Dear Mr. Brown:                    Re: Vietnam Veterans Memorial

RE: VIETNAM VETERANS MEMORIAL OR A HOAX SHROUDED BY  
A CONSPIRACY OF SILENCE.

# VIETNAM VETERANS MEMORIAL

## SECTION THROUGH MEMORIAL WALL AT CENTER

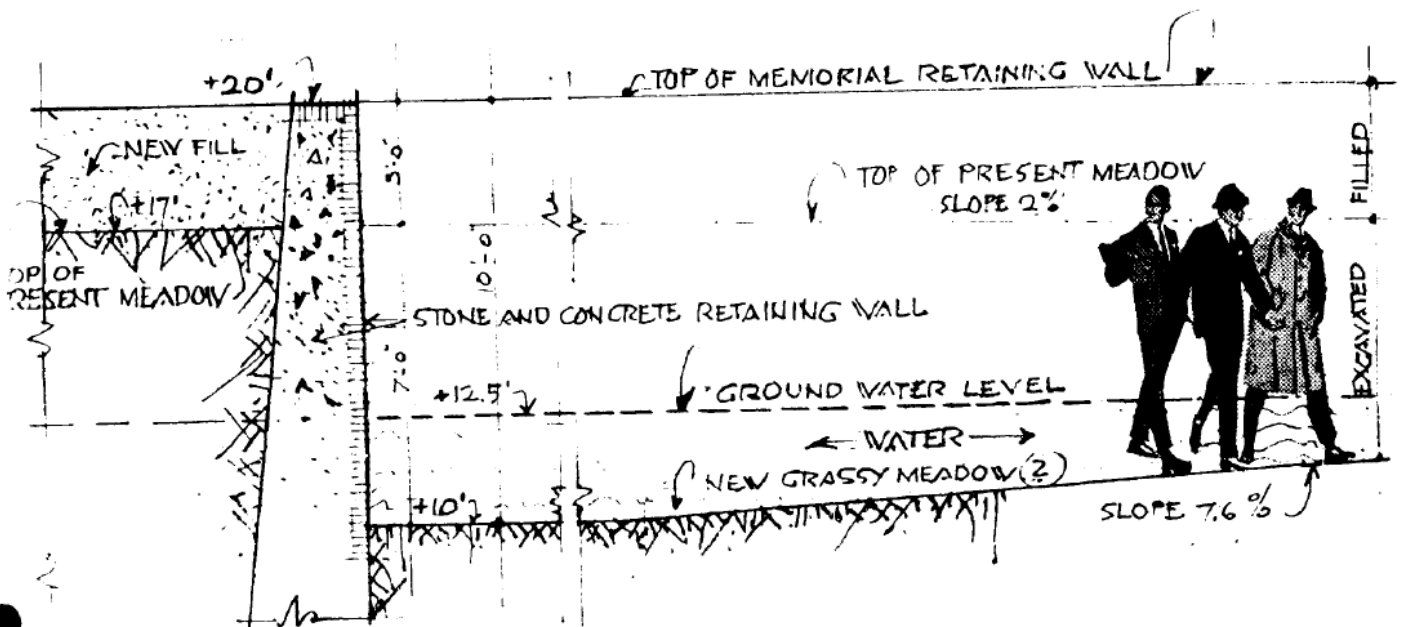
**Comment:** The jury selected a design that brought about an incongruous concept of retaining walls on flat land. In order to accomplish its feature the contours of the site were substantially modified, requiring digging into land where ground water was encountered. The change of levels, created adverse slopes of 7.6% - thus immobilizing wheelchair invalids' approach to the memorial.

If the horizontal level of the top of the retaining walls were to be +20', as it is implied by the winning design, the 10' high retaining walls would extend 2.5' below ground water level and 7 feet below existing contours at the center part of the memorial, thus converting the "grassy meadow" into an impounded pond, inaccessible to those who may wish to visit the memorial at its main level, and in addition creating a deadly precipice at the upper level because of the unprotected drop between the two (please refer to section through the memorial wall on the front page of this brief).

From above revelations, it becomes apparent that the concept selected by the jury does not fit the site, and the insurmountable obstacles stated above make the memorial unbuildable.
